**SUBJECT: COMANCHE PEAK STEAM ELECTRIC STATION (CPSES)  
DOCKET NO. 50-445  
RELIEF REQUEST B-2 TO THE UNIT 1 INSERVICE INSPECTION  
(ISI) FROM 1986 EDITION OF ASME CODE, SECTION XI, NO  
ADDENDA (INTERVAL START DATE: AUGUST 14, 2000, SECOND  
INTERVAL)**

**TXU GENERATION COMPANY LP  
COMANCHE PEAK STEAM ELECTRIC STATION UNIT 1  
FIRST TEN-YEAR INTERVAL ISI RELIEF REQUEST NO. B-2**

**PROPOSED ALTERNATIVE IN ACCORDANCE WITH 10 CFR 50.55a(g)(5)(iii)  
-INSERVICE INSPECTION IMPRACTICALITY-**

NOTES: REF. 1-2100 FOR ORIENTATION	DESCRIPTION: PRESSURIZER RELIEF	TU ELECTRIC
	T/SCH: (6) 719/160, (3) 438/160	CPES UNIT 1
	BRP: RC-1-RB-28A, RC-1-RB-15	INSERVICE INSPECTION LOCATION ISOMETRIC
APPROVAL: <i>J.H.H.</i> 7/24/90	FLOW: HI-0251	TBX-1-4502 REV. 1 / 7-24-90

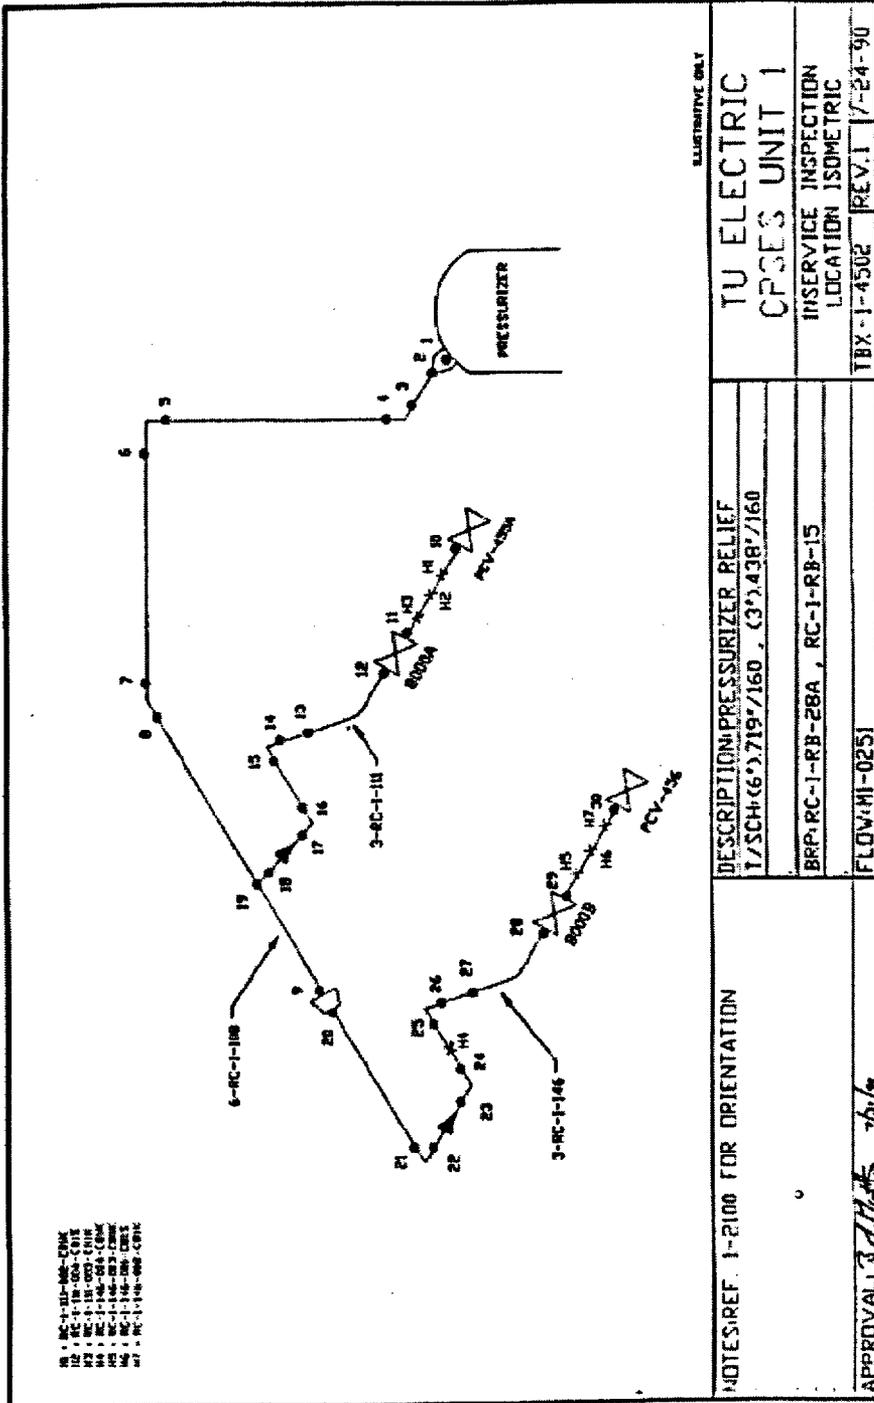
Relief is requested for the following Class 1 piping welds in the Reactor Coolant System (Pressurizer Relief), Category B-J, Item B9.21, 1986 Edition with no Addenda of ASME Section XI:

Weld No. TBX-1-4502-12  
Weld No. TBX-1-4502-28

This relief request will modify the former RI-ISI relief request to perform surface examinations and volumetric examinations where feasible on the Category B-J welds listed in Section I.

These two welds were the only welds identified in the line segments per the RI-ISI Program which met the considerations for system design, the risk analysis, previous examinations, and NDE accessibility, and this is the first time these welds were examined via the UT methodology. Additionally, these welds have been previously examined via the liquid penetrant examination method and no matters of concerns had been identified (e.g., no flaws were noted).

Therefore, TXU Energy believes that the examination performed provides adequate confidence that there are no matters of concern regarding the structural integrity of the subject welds. No changes are expected in the overall level of plant safety. TXU Energy will perform a surface examination along with the volumetric examination where feasible as specified by the ASME Section XI for these welds during the next upcoming outage (or within this second interval for CPSES Unit 1).
